PROJECT: DC Plaza

SUBMITTAL: 1st Submittal

CITY OF LAS VEGAS		DATE:
INTER-OFFICE MEMORANDUM		December 22, 2014
TO: Land Development Services Department of Building & Safety		FROM: Albert Sung, P.E. Flood Control Project Engineer Department of Public Works
SUBJECT:	Drainage Study for: DC Plaza	COPIES TO: Civil Squared Engineering
Cross Streets:	South of Durango Drive & Farm Road	Farm & Durango Investors LLC
File Number:	F:\Depot\DSMemos\DS4710A.doc	Bart Anderson, P.E., DevCo
Parcel Number:	125-17-601-007; -010; -013 & -015	NDOT
Zoning Action:	SDR-XXXXX and more	
FEMA Flood Zone	YES NO X	
Proposed Storm Drain	YES NO X

SUBJECT: Drainage Study for:
 DC Plaza

STREET PLAN AND PROFILE
DURANGO DRIVE
LOWE'S OF CAROLINE'S COURT
LAS VEGAS, NEVADA

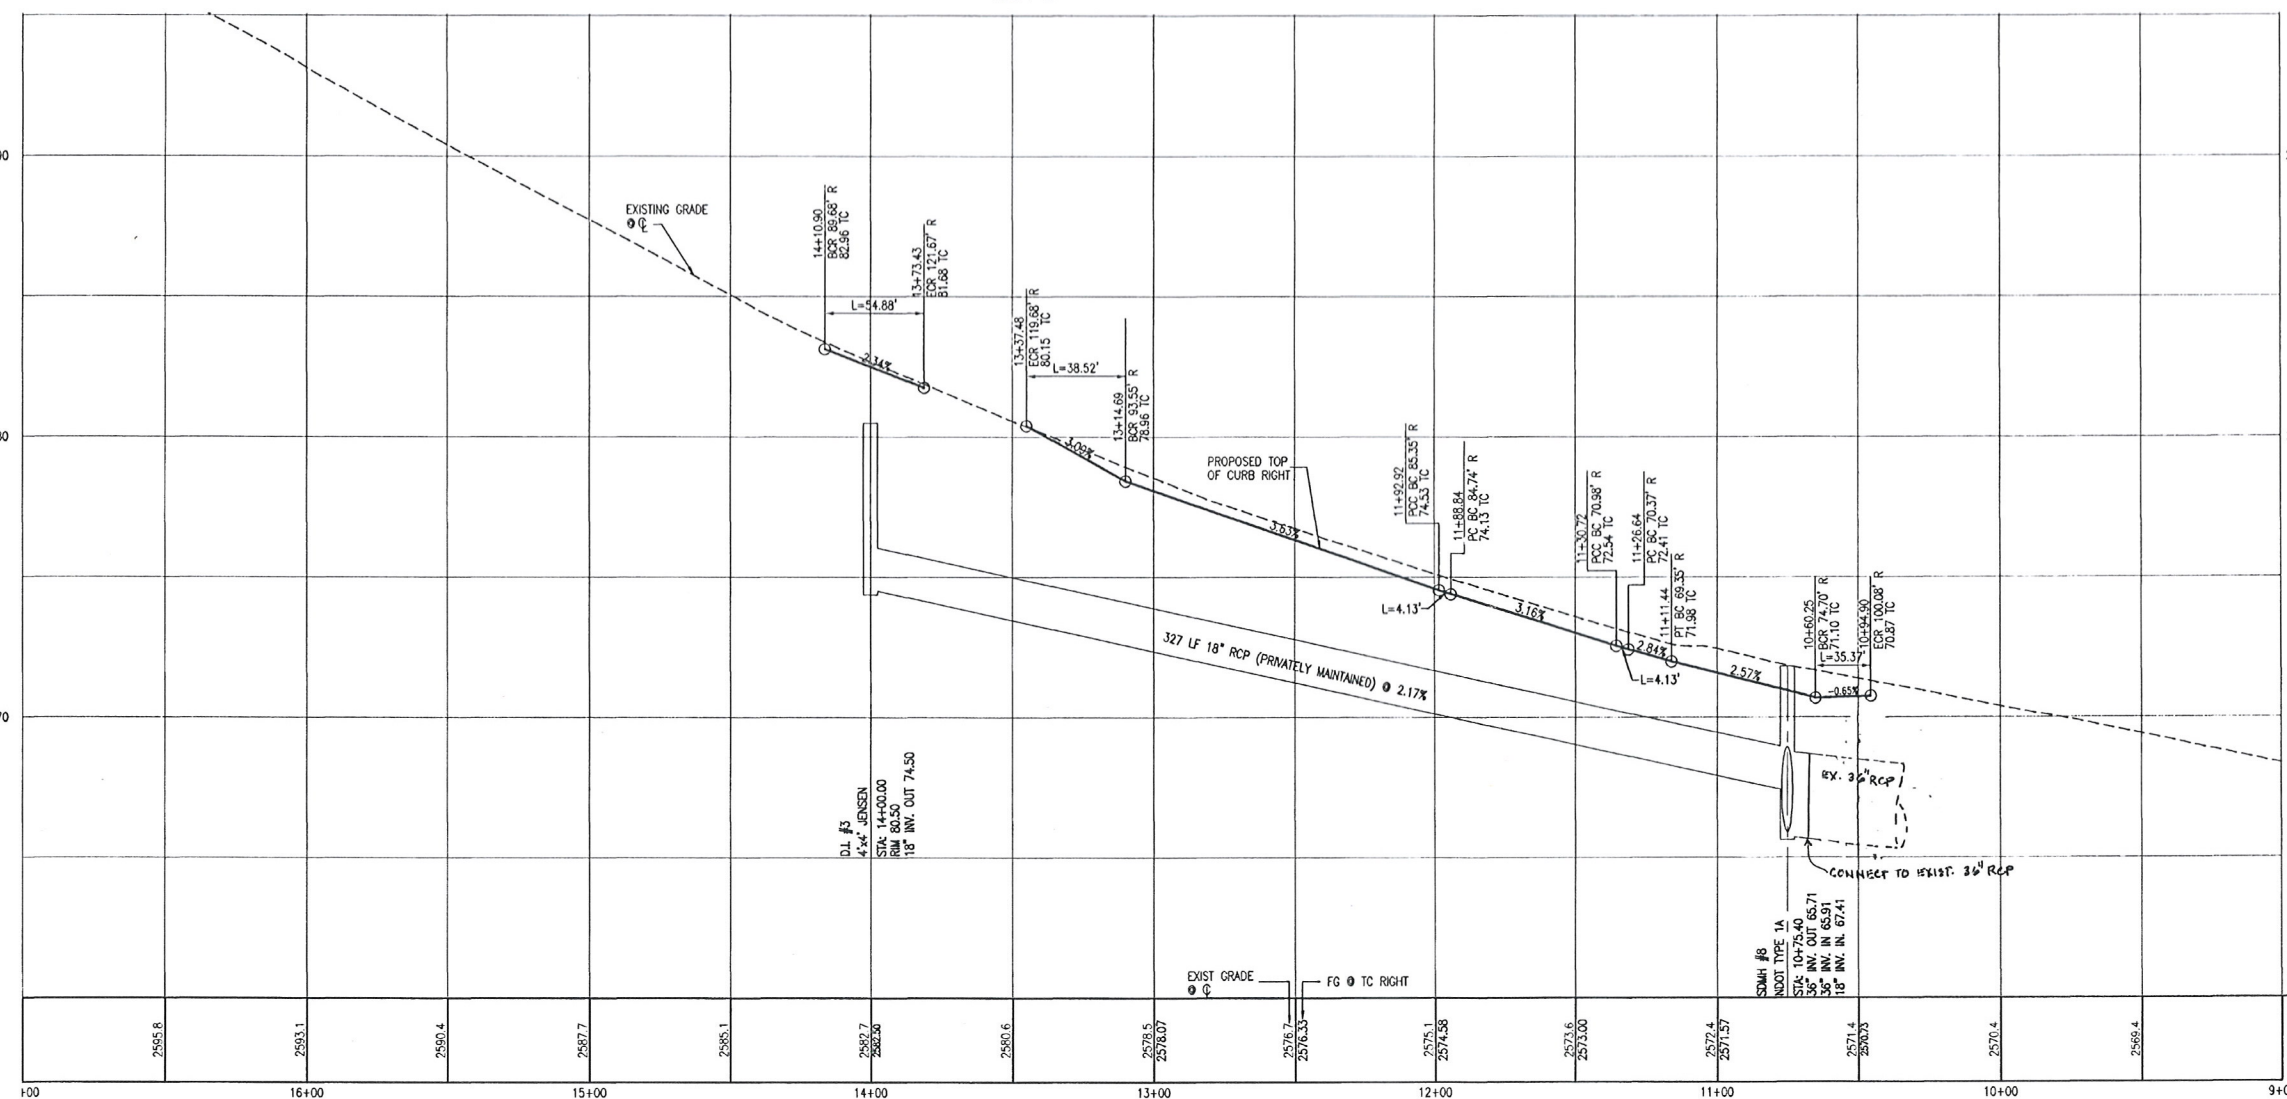
7. Per the street improvement plans of **Lowe's of Caroline's Court** project (**Sheet C-4.7**), the three (3) stated drop inlets on the east side of *Durango Drive* are indeed connected to each of their corresponding inlets on the west side of *Durango*. The stated sub-basins for each inlet in *Durango Drive* in the subject study (**Figure-10** and **Figure-11**) are therefore incorrect. Each sub-basins must include the west half of *Durango Drive*.

STATE OF NEVADA DEPARTMENT OF TRANSPORTATION	
DURANGO DR. / US 95 INTERCHANGE	
73	107V3813
DRAINAGE PLAN	
DESIGN BY DRAWN BY CHECKED BY REVIEWED BY	BOH L.S. KDC

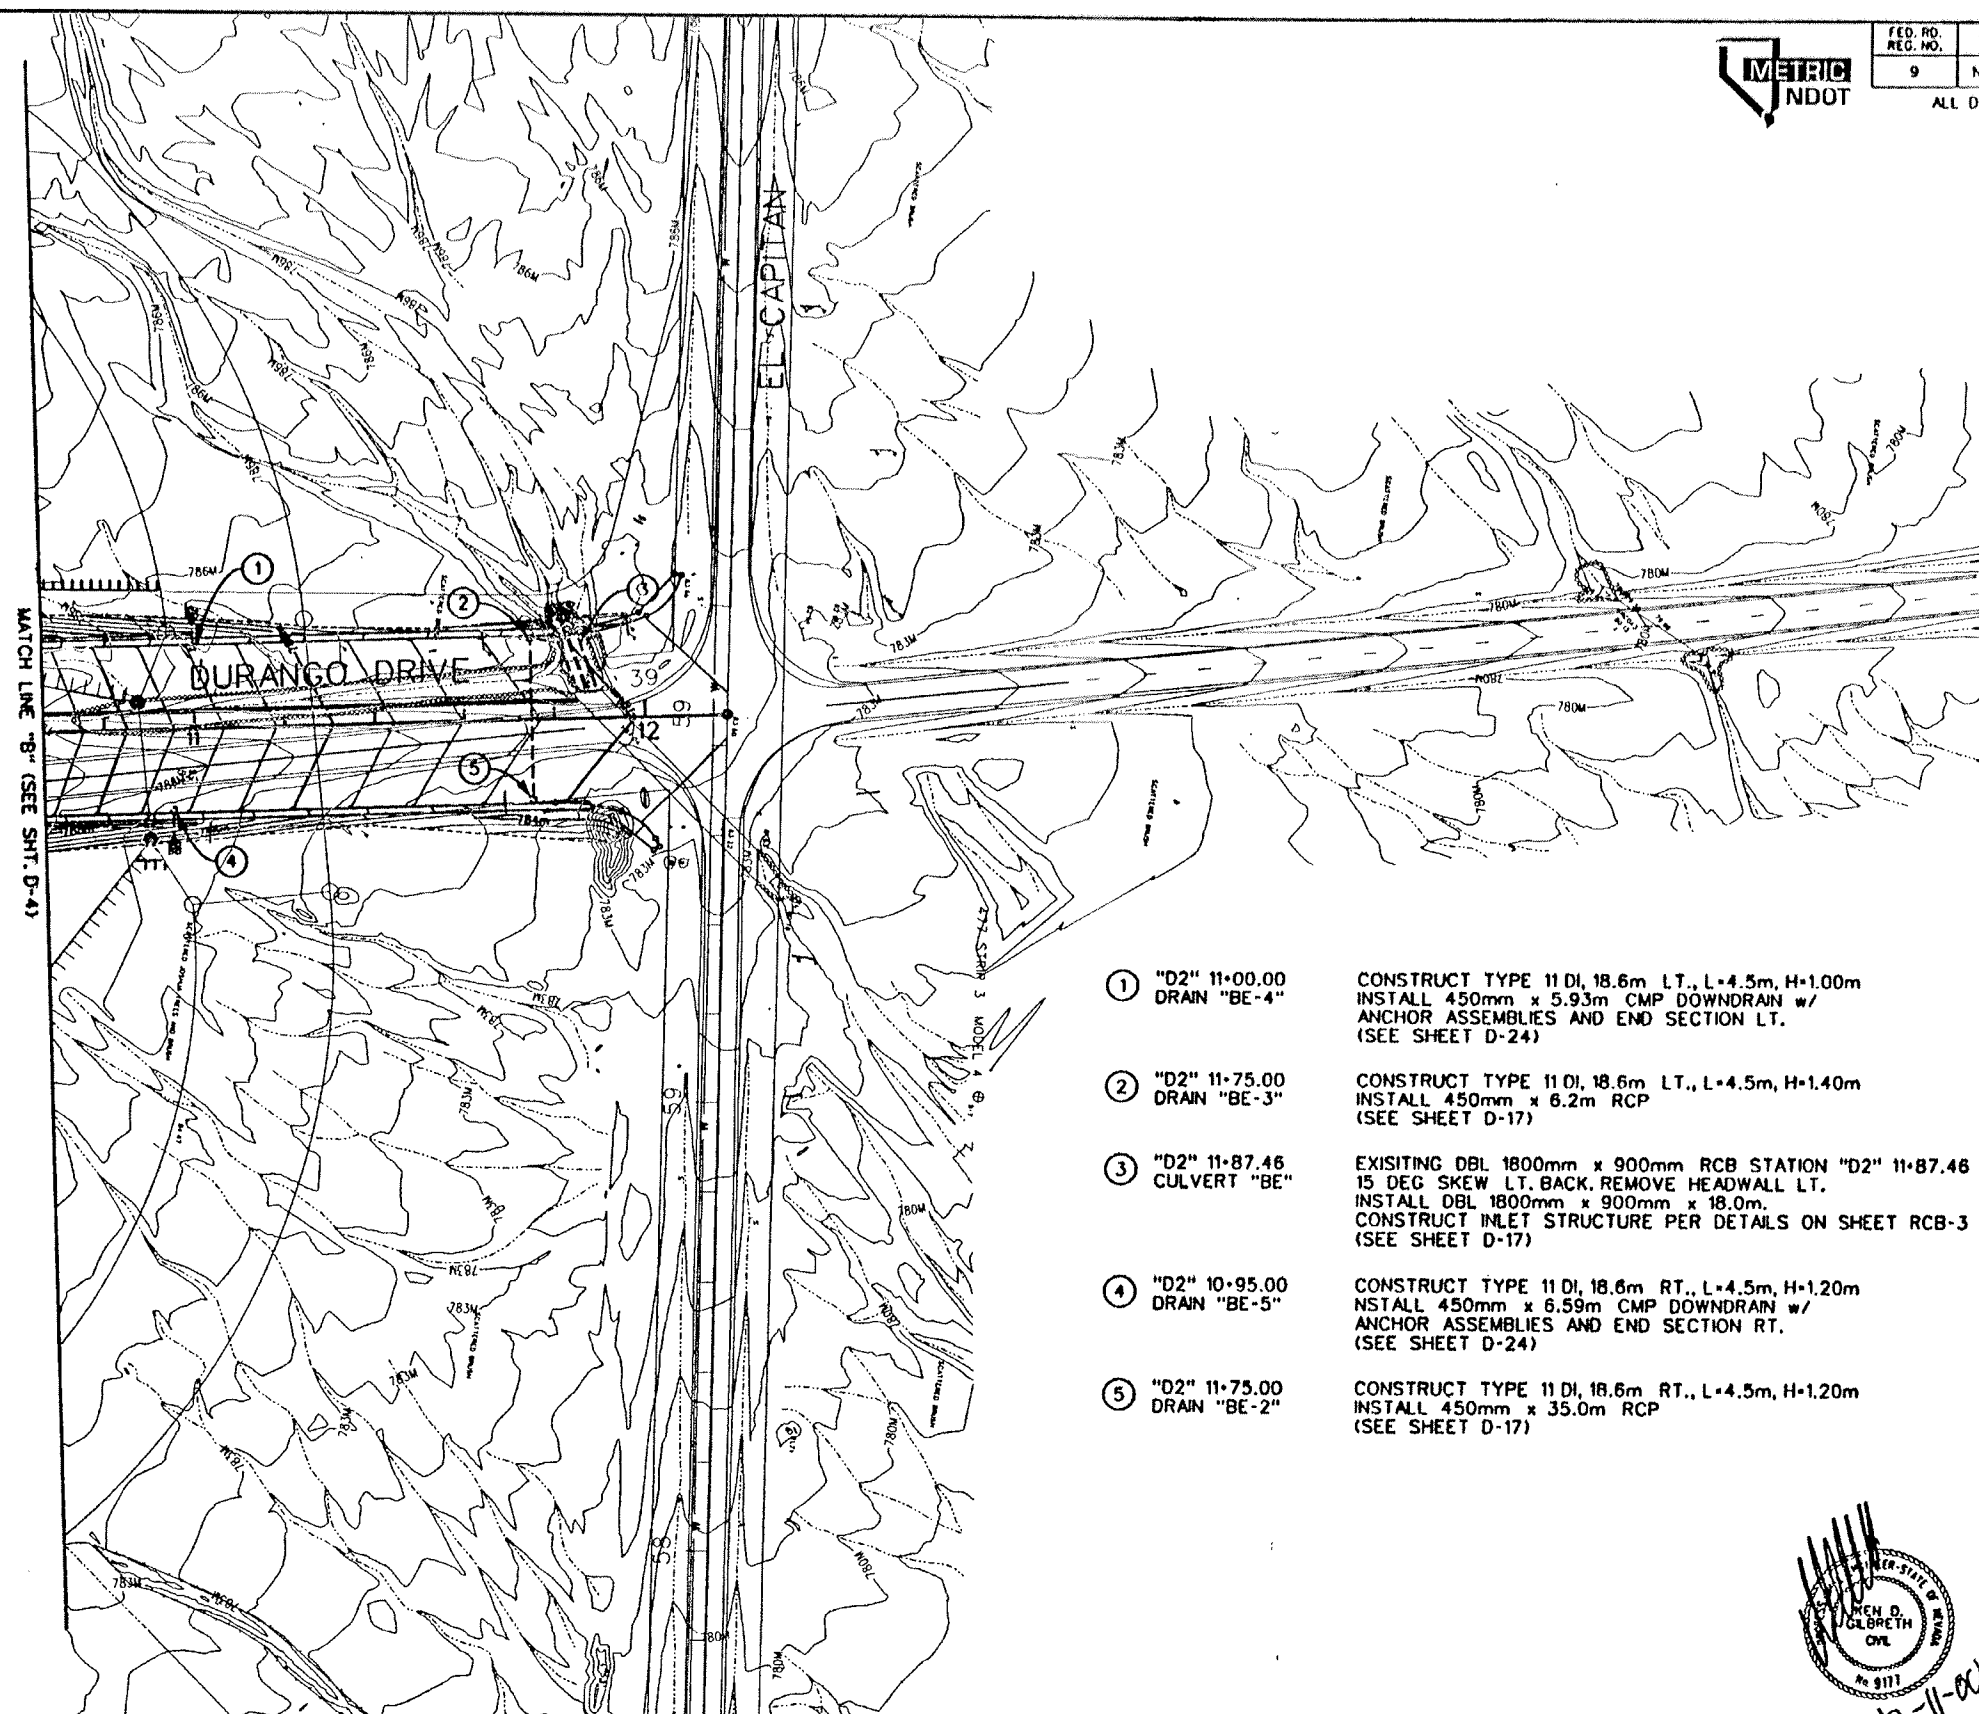
Per the 5'-contours on GISMO, it appears that the bridge deck of *Durango Drive* over U.S 95 is the true high point of *Durango Drive*. Sub-basin "STD1a" may need to be expanded. Provide topographical survey to prove otherwise. This must be addressed in the next submittal.
